CITY OF ALBUQUERQUE

Re: Lowes Subdivision Lot 3
Grading and Drainage Plan
Engineer's Stamp dated 2-8-12 (A14/D006B)

REFERENCE: Lowe's Subdivision Lot 3 (A14 / D006B)

OFF-SITE STORM DRAIN INLETS

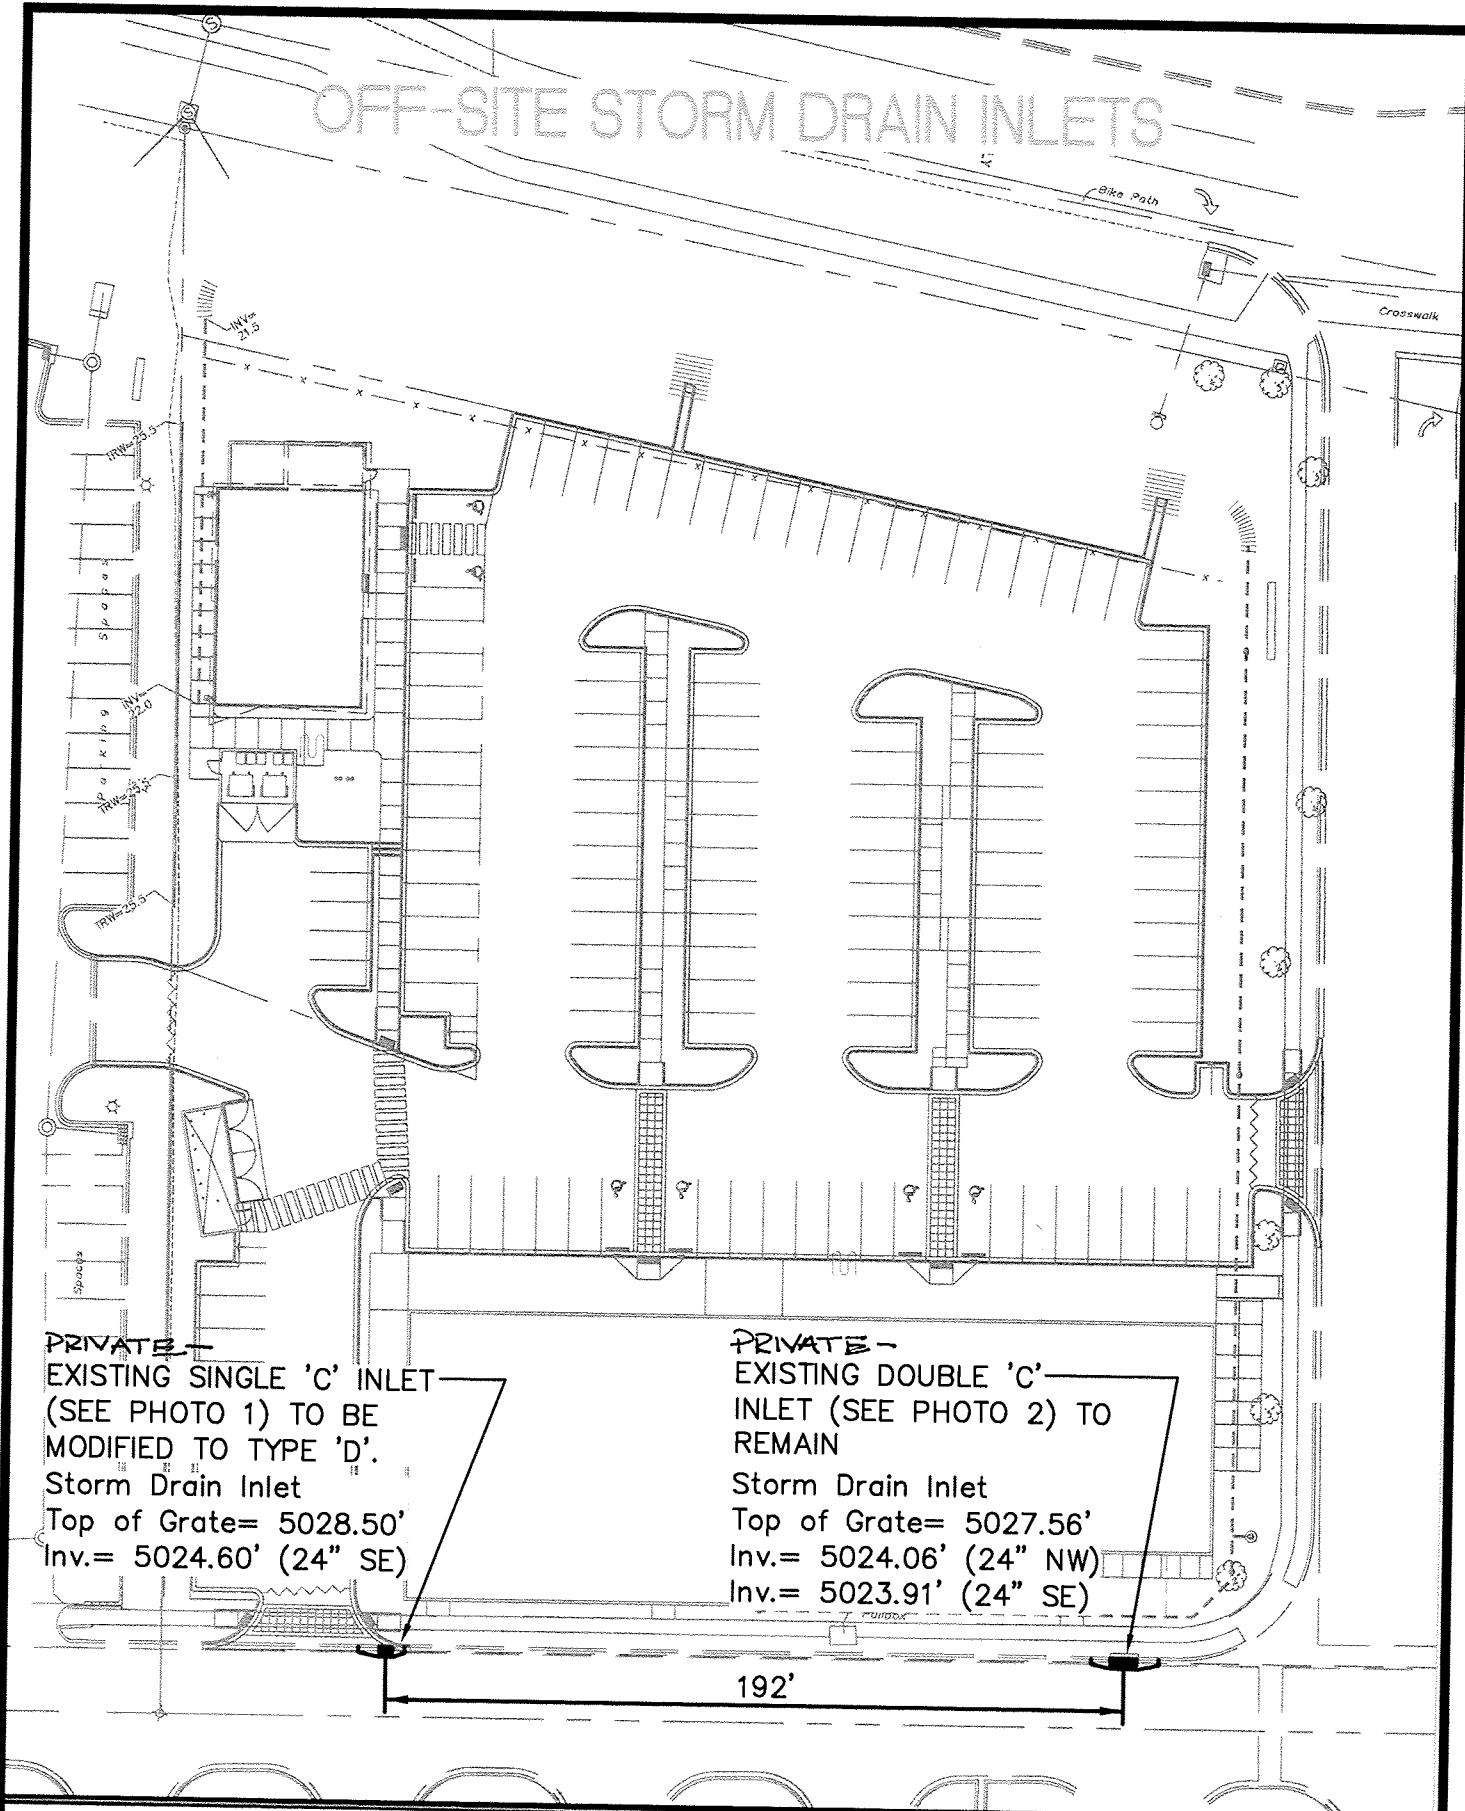
Per the attached exhibit and photographs, there is a double 'C' inlet just downstream of the single 'C' inlet which we are calling to modify to a Type 'D'. Any trash which may have been captured at the upstream 'C' will now be captured at the downstream 'C' (ALL INLETS ARE PRIVATE).

GRADING AND DRAINAGE PLAN

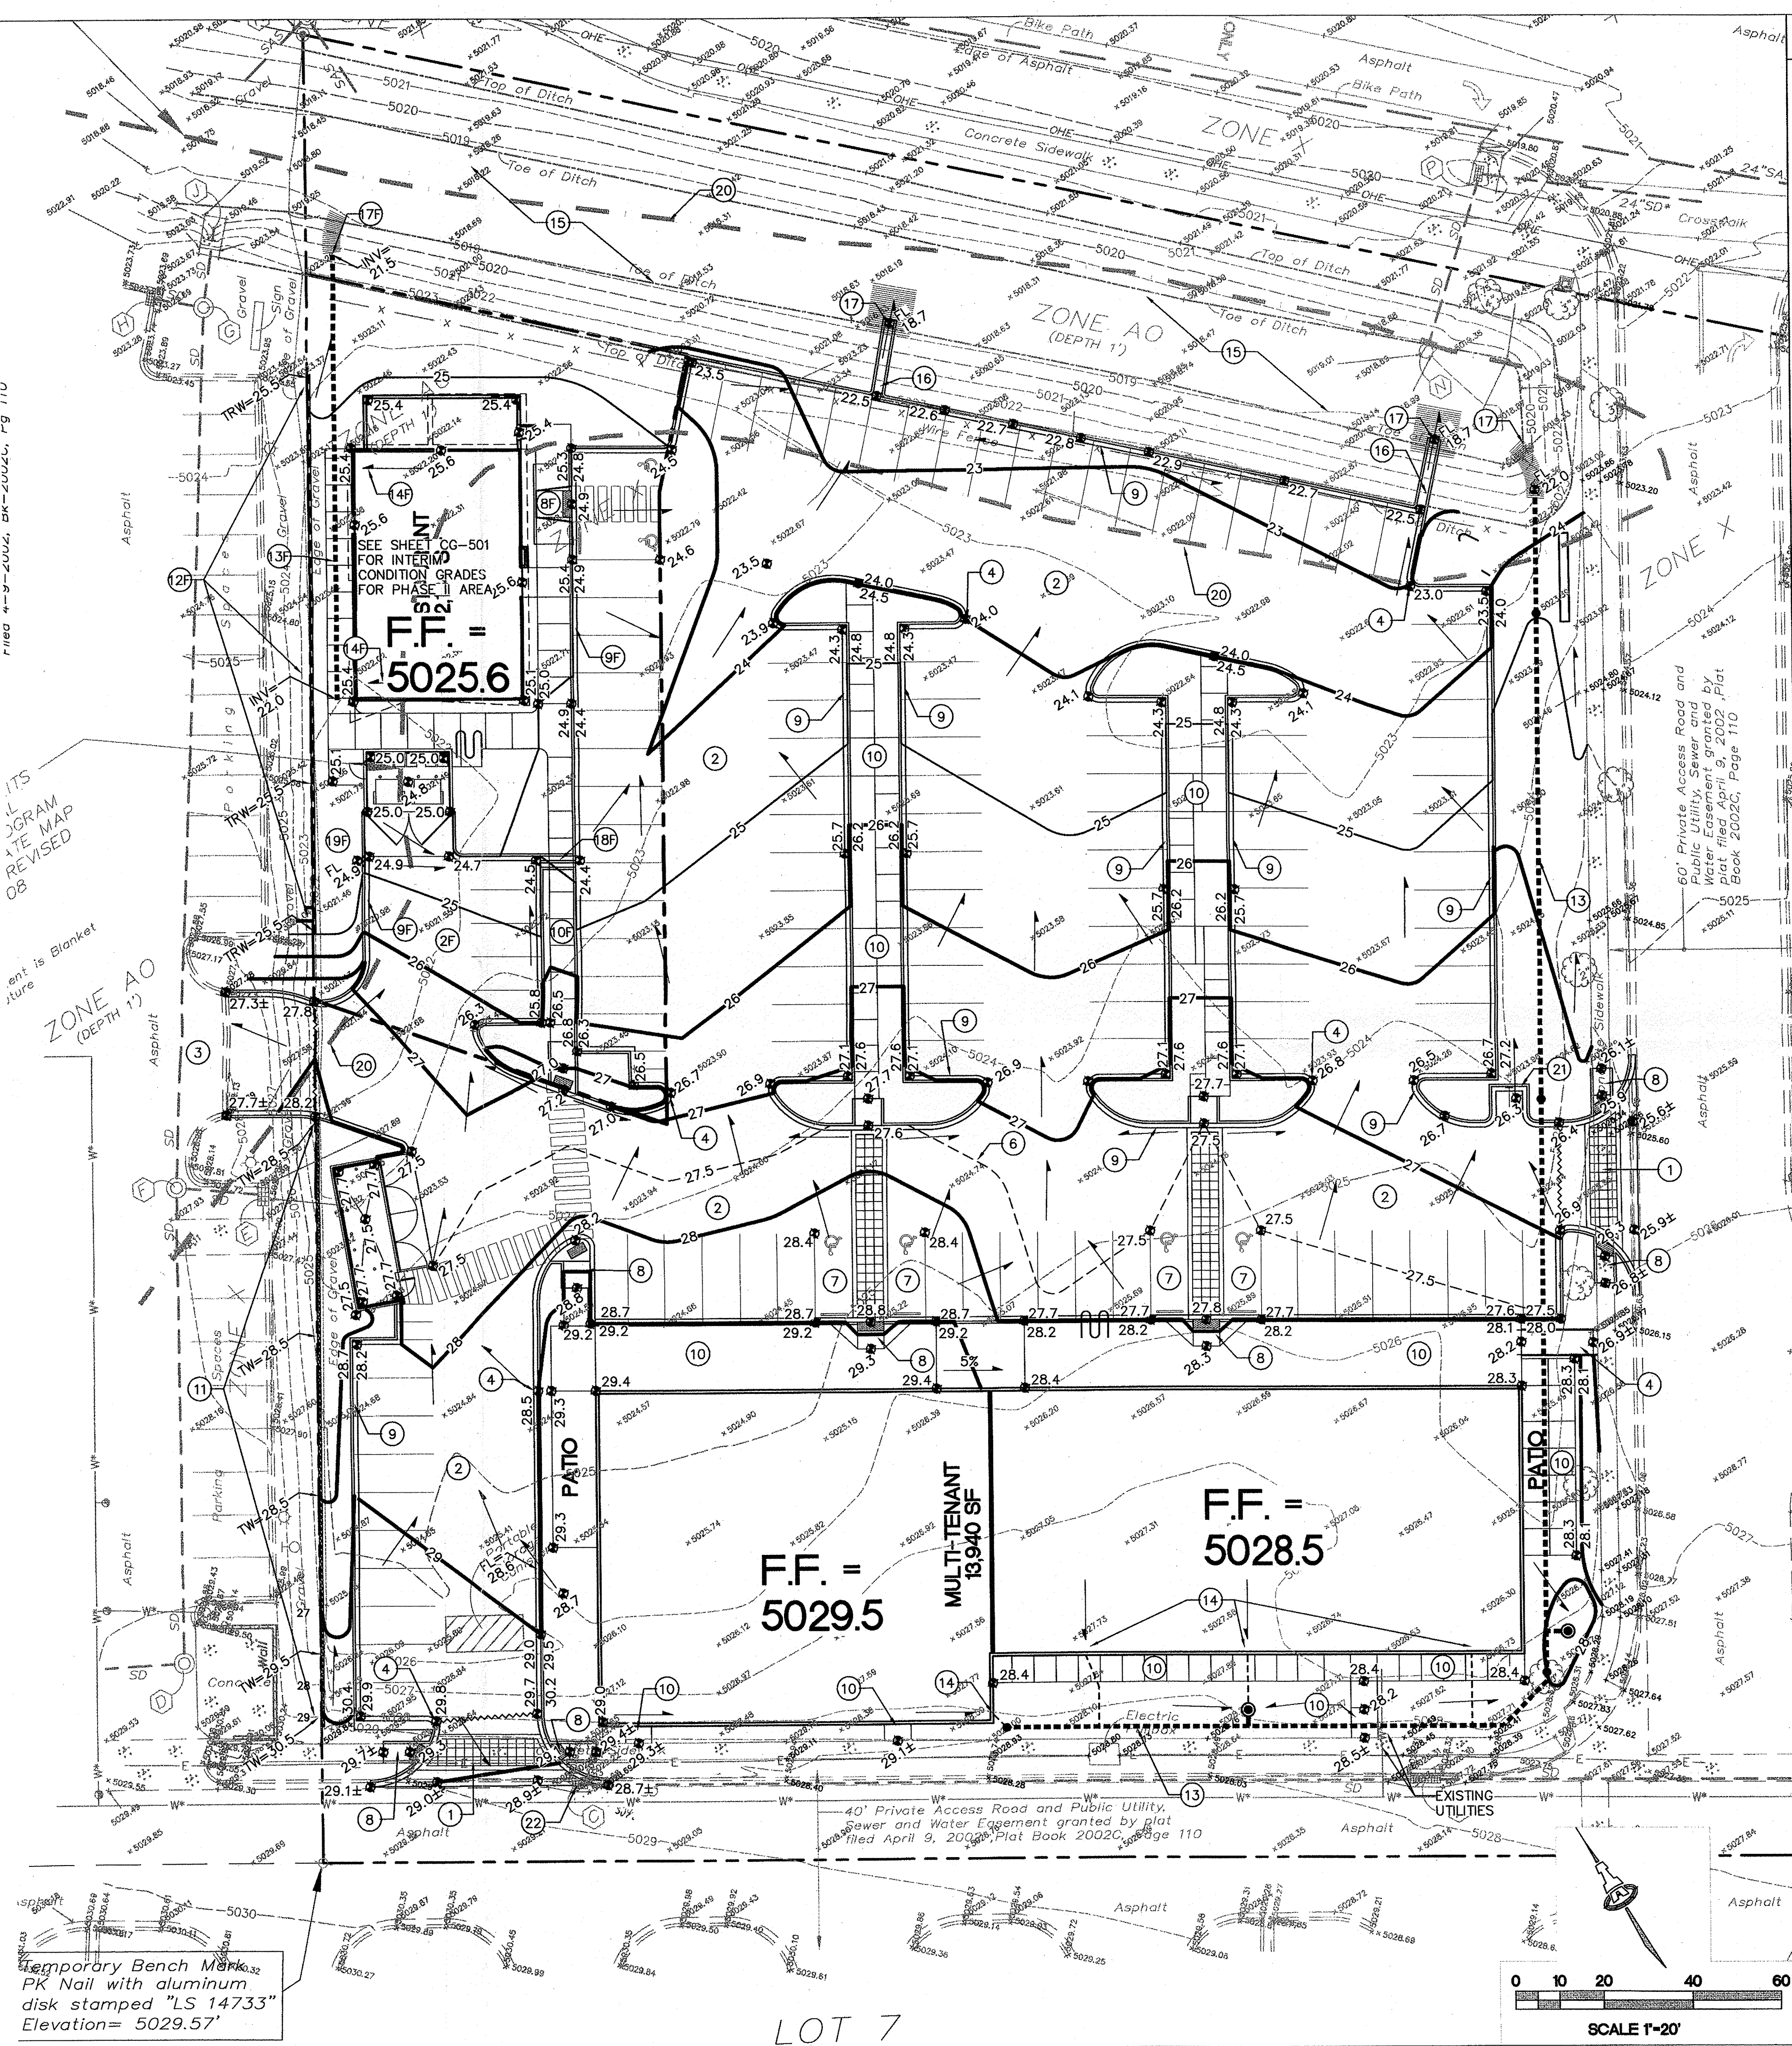
Before phase II can receive a C.O. an Elevation Certificate must be submitted for review and approval. Also, the dumpster pad must drain into the SAS via a grease trap.

Hydrology is requesting that all proposed landscape areas are depressed to retain/infiltrate the moisture that falls on them.

We have included two Floodplain Permit Forms - one for each of the two phases. Our client understands that an Elevation Certification will be required for the Phase II building until the LOMR being prepared by Chuck Easterling is accepted (see keyed note 20). General Note regarding depressed landscaping has been added to the plan.

20. EXISTING FLOODPLAIN LIMIT (ZONE AO 1' DEPTH). ELEVATION CERTIFICATE REQUIRED FOR PHASE II BUILDING.
 21. PROVIDE 12" WIDE OPENING IN CURB TO PASS MINOR FLOW TO LANDSCAPE.

22. MODIFY EXISTING STORM DRAIN INLET TO C.O.A. TYPE 'D' PER C.O.A. STD. DWG. 2206. MATCH RIM ELEVATION.

- K. LANDSCAPED AREAS SHALL BE DEPRESSED TO RETAIN MOISTURE THAT FALLS ON THEM FOR INFILTRATION. DO NOT DEPRESS LANDSCAPING WITHIN 10' OF BUILDING.
